CITY OF KELOWNA

MEMORANDUM

Date:May 24, 2022File No.:Z22-0030

Subject: 394 VIEWCREST CT Lot 17 Plan KAP53665 Carriage House RU1 to RU1c

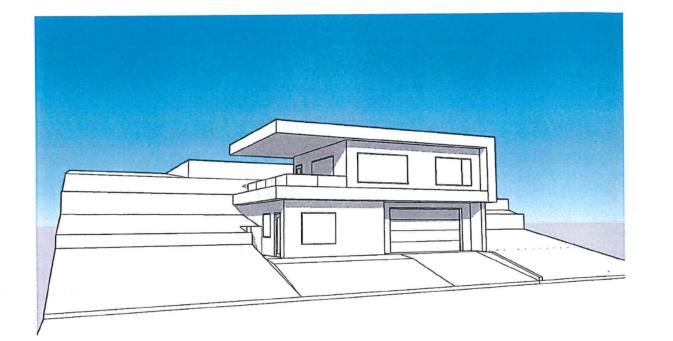
Where walls are on the high side, the City's preference is that the walls remain setback and on private property. Where the walls hold up a public road, the City's preference is that additional dedication be provided, and the walls be owned by the City. Please design any geogrids or tiebacks so that they do not encroach into the required road ROW.
